World Forum for Harmonization of Vehicle Regulations

Proposal for the 05 series of amendments to UN Regulation No. 95 (Lateral collision protection)

Submitted by the Working Party on Passive Safety *

Figure 4

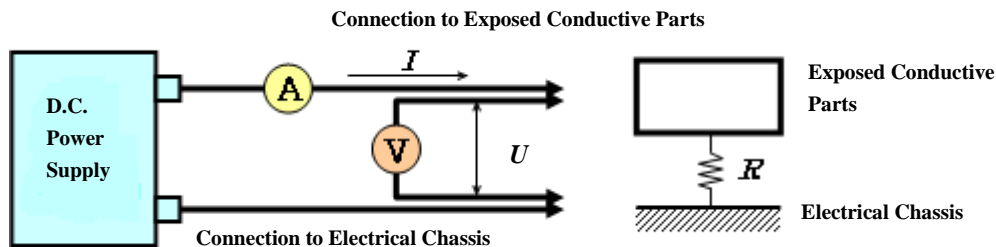
Paragraph 4., amend to read:

barrier) and the resistance is measured using a resistance tester that meets the specification that follows:

- (i) Resistance tester: Measurement current at least 0.2 A;
 - (ii) Resolution: 0.01 Ω or less;
 - (iii) The resistance R shall be less than 0.1 Ω .
- (b) Test method using DC power supply, voltmeter and ammeter.

The DC power supply, voltmeter and ammeter are connected to the measuring points (Typically, electrical chassis and electro conductive enclosure/electrical protection barrier).

The voltage of the DC power supply is adjusted so that the current flow becomes at least 0.2 A.

The current "I" and the voltage "U" are measured.

The resistance "R" is calculated according to the following formula:

The resistance R shall be less than 0.1 Ω .

Note: If lead wires are used for voltage and current measurement, each lead wire shall be independently connected to the electrical protection barrier/enclosure/electrical chassis. Terminal can be common for voltage measurement and current measurement.

Example of the test method using DC power supply, voltmeter and ammeter is shown below.

Figure 5
Measurement of U_1'

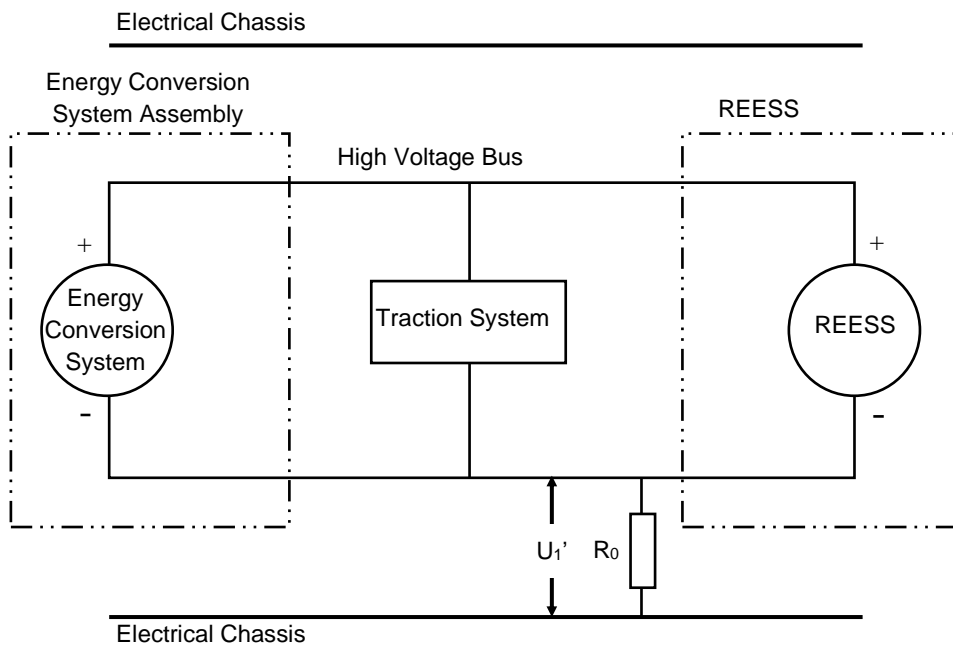
If U_1 is greater than or equal to U_2 , a standard known resistance (R_o) is inserted between the negative side of the high voltage bus and the electrical chassis. With R_o installed, the voltage (U_1') between the negative side of the high voltage bus and the electrical chassis is measured (see Figure 5).

The electrical isolation (R_i) is calculated according to the following formula:

$$R_i = R_o * U_b * (1/U_1' - 1/U_1)$$

Figure 6
Measurement of U_2'

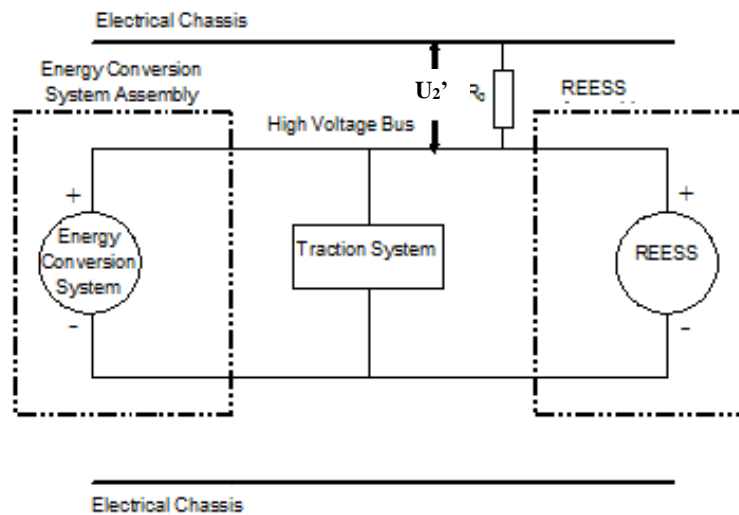
If U_2 is greater than U_1 , insert a standard known resistance (R_o) between the positive side of the high voltage bus and the electrical chassis. With R_o installed, measure the voltage (U_2') between the positive side of the high voltage bus and the electrical chassis (see Figure 6 below). The electrical isolation (R_i) is calculated according to the following formula:

$$R_i = R_o * U_b * (1/U_2' - 1/U_2)$$
